**Draft RAI Responses to RAIs NP-2.2-1, NP-2.2-2
and EP-X
(Non-Proprietary Version)**

Safety Analysis Report (SAR), Chapter 2, "Site Characteristics"**RAI NP-2.2-1:**

Figure 2-39
Low Altitude Air Routes Passing Near the Site

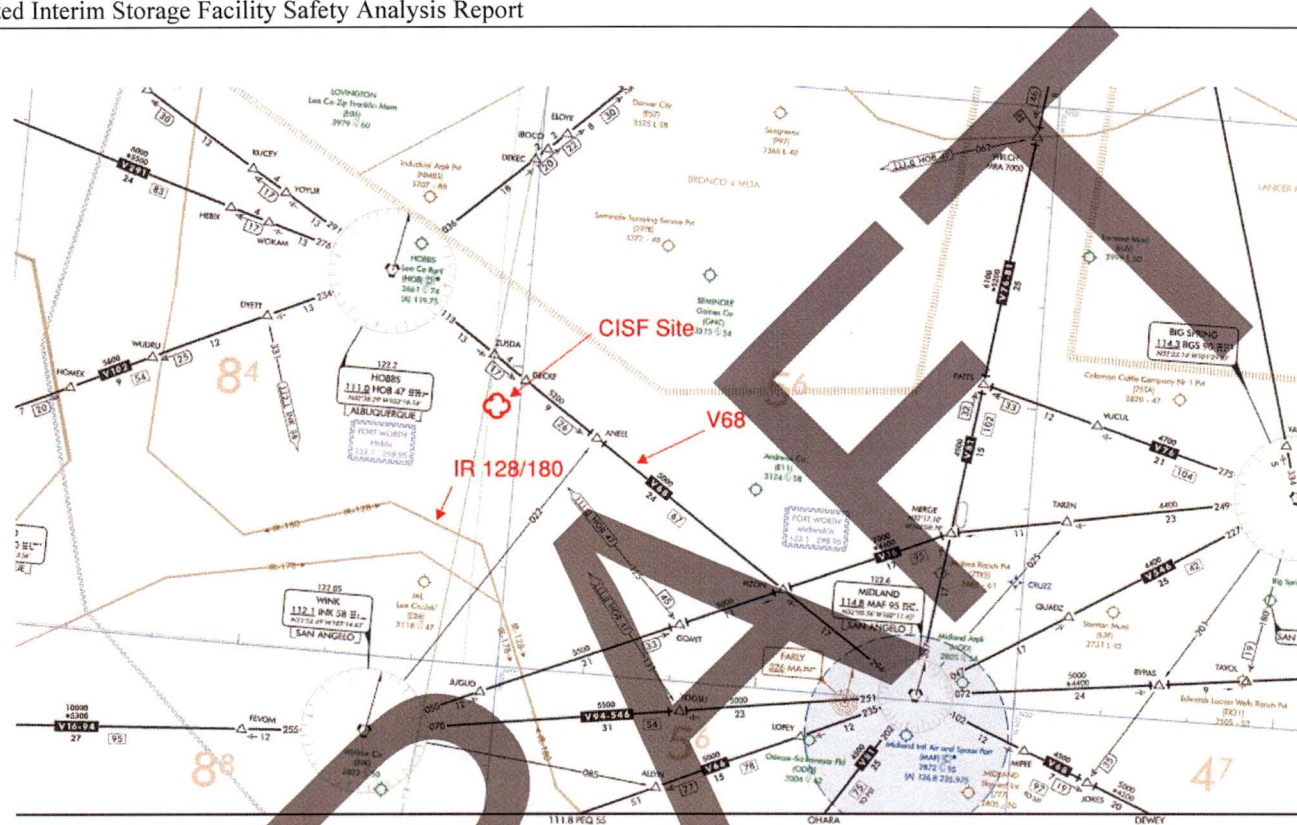
Provide an evaluation and aircraft crash probability impact analysis of airway V68, which passes nearby the proposed WCS CISF, in accordance with guidance and acceptance criteria provided in NUREG-1567, Section 2.4.2.

During the NRC staff's review of the information presented in WCS CISF SAR Section 2.2, "Nearby Industrial, Transportation and Military Facilities," the NRC staff identified an airway V68 passing nearby the proposed WCS CISF, which is not addressed by ISP. The closest airport identified is the Lea County Airport, which is 18 miles from the WCS CISF. Provide an analysis and evaluation of airway V68 and incorporate the changes, as appropriate in the application.

ISP performed an aircraft hazards evaluation for the WCS CISF and added a summary of that evaluation in new SAR Section 2.2.1, Aircraft Hazard Evaluation. The evaluation uses the guidance in NUREG-0800. The evaluation results, based on site-specific flight information and nearby airport locations, indicate that the annual probability of aircraft crash at the WCS CISF is approximately $3.81\text{E-}7$. Using an alternative conservative approach (i.e., that all flights pass over the site), the annual probability of occurrence is computed to be less than $7.38\text{E-}7$. Both probabilities are below the NRC annual probability of occurrence threshold of $1.0\text{E-}6$ for aircraft crash as articulated in NRC Memorandum and Order CLI-01-22. On this basis, ISP concludes that aircraft crash presents low risk to public health and safety and is therefore not necessary to be included as a design basis consideration. SAR Section 2.8 References has also been updated to include the new references added in Section 2.2.1. Also included with the RAI response is a copy of the Proprietary Aircraft Hazard Evaluation Report which forms the basis for SAR Section 2.2.1.

Low Altitude Airways (Figure 2-38 and Figure 2-39) [2-45]

- V68 is a low-altitude east-west route (113° out of Lea County Regional Airport N32°38.29' W103.16.16' toward Midland Airpark Airport N32°00.56' W102°11.42'). Its centerline passes approximately 4 miles from the plant site and has a width of 9.21 miles (8 nautical miles).

Figure 2-3
Proposed WCS CISF 5-mile Radius

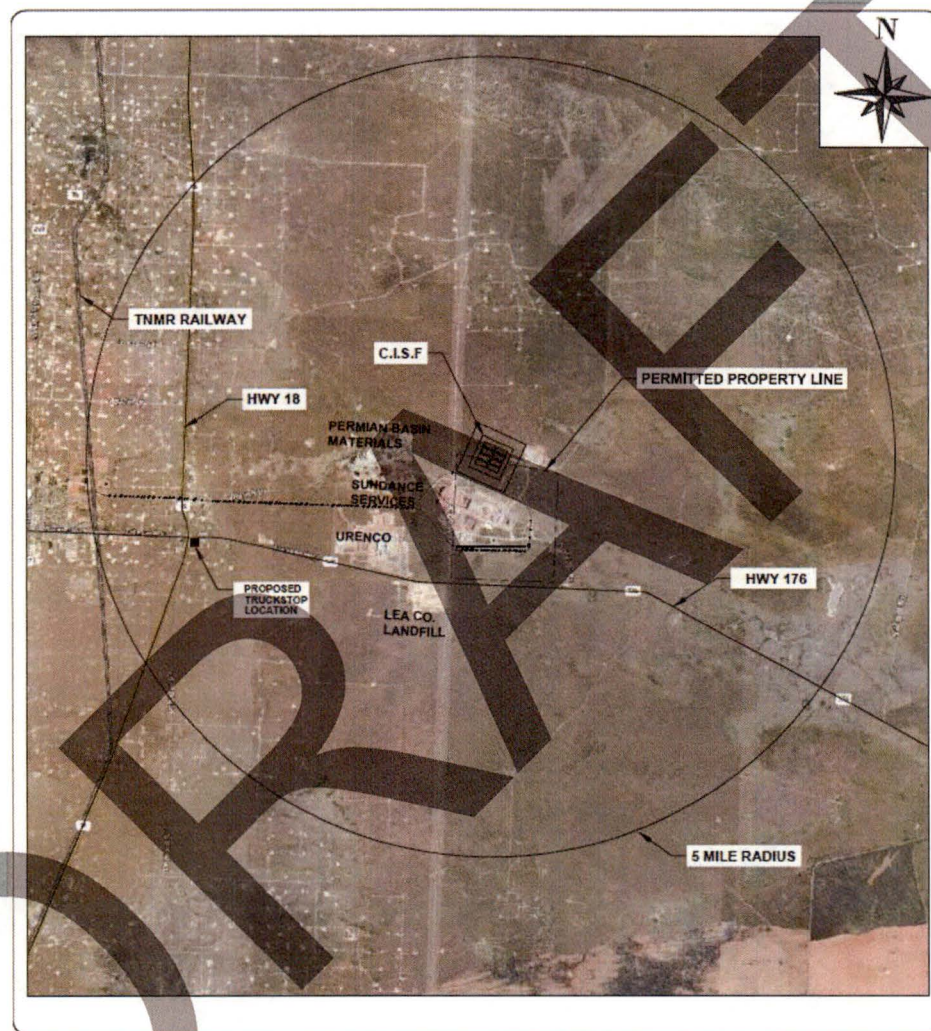
Provide the locations of nearby industrial, transportation, military, and nuclear installations. Describe potential hazards to the proposed WCS CISF from activities or materials at those facilities in accordance with the guidance and acceptance criteria provided in NUREG-1567, Section 2.4.2.

During the NRC staff's review, the NRC staff determined that ISP identified nearby facilities, but did not provide potential impact evaluations of these facilities on the proposed WCS CISF. Specifically, ISP identified a railroad, but did not provide details on products/materials transported by rail; the distance of the rail line from the proposed facility; or the potential impacts (if any) on the proposed facility. ISP identified Texas State Highway 176, but not the shortest distance between the highway and the proposed facility. ISP stated oil industry pipelines are located near the facility in WCS CISF SAR Section 12.2.2, but did not provide details as to what materials are transported in the pipelines; the distance of the pipelines from the proposed facility; or the impacts of the pipelines on the proposed facility. Different materials can be transported through these pipelines and these different materials can pose different potential hazards to the site.

Section 2.2 of the SAR is updated to include discussion of New Mexico State Highway 18, the Texas & New Mexico Railway, the Energy Transfer LP pipeline, the Love's travel stop, and reference to the evaluations discussed in Section 12.2.2. Figure 2-3 is updated to include facilities within a radius of 8-km (5-miles).
